Service Bulletin

Bulletin No.: 20-NA-096

Subject: Glow Plug Control Module Update

Brand:	Model:	Model Year:		VIN:		Engine:	Transmission:
		from	to	from	to		
Chevrolet	Silverado 2500HD/ 3500HD	2020	2020			L5P	All
	Silverado 4500HD/ 5500HD/ 6500HD	2020	2020			L5D	
GMC	Sierra 2500HD/ 3500HD	2020	2020			L5P

5431207

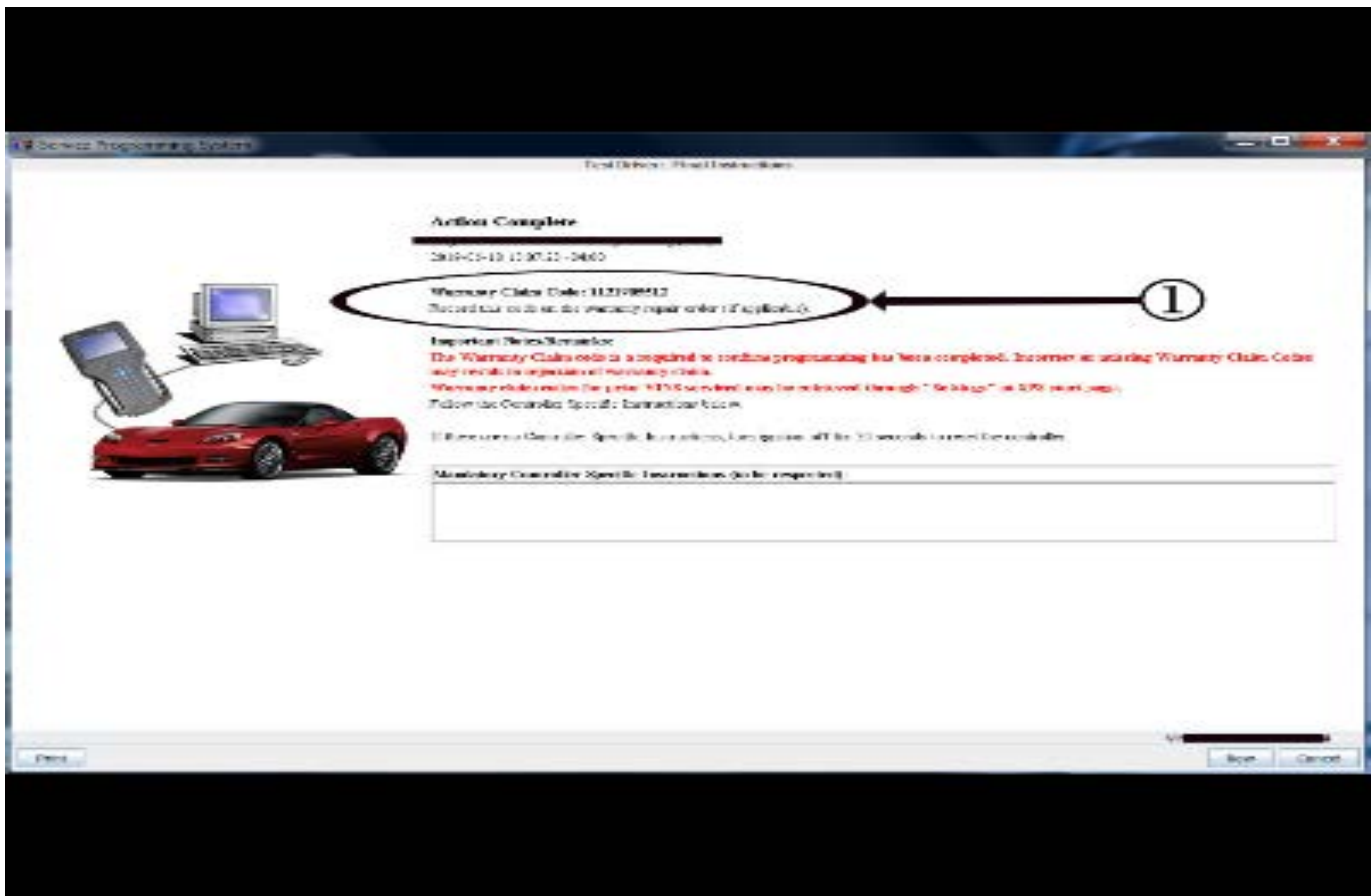
Important: TIS2WEB screen shown. Techline Connect screen is similar and will be included soon.

Important: If the Same Calibration/Software Warning is noted on the SPS screen, select OK and follow screen instructions. After a successful programming event, the WCC is located in the Service Programming

System dialogue box of the SPS Summary screen. No further action is required. Refer to the Warranty section of the bulletin.

1. Reprogram the Glow Plug Control Module. Refer to *K34 Glow Plug Control Module: Programming and Setup* in SI.
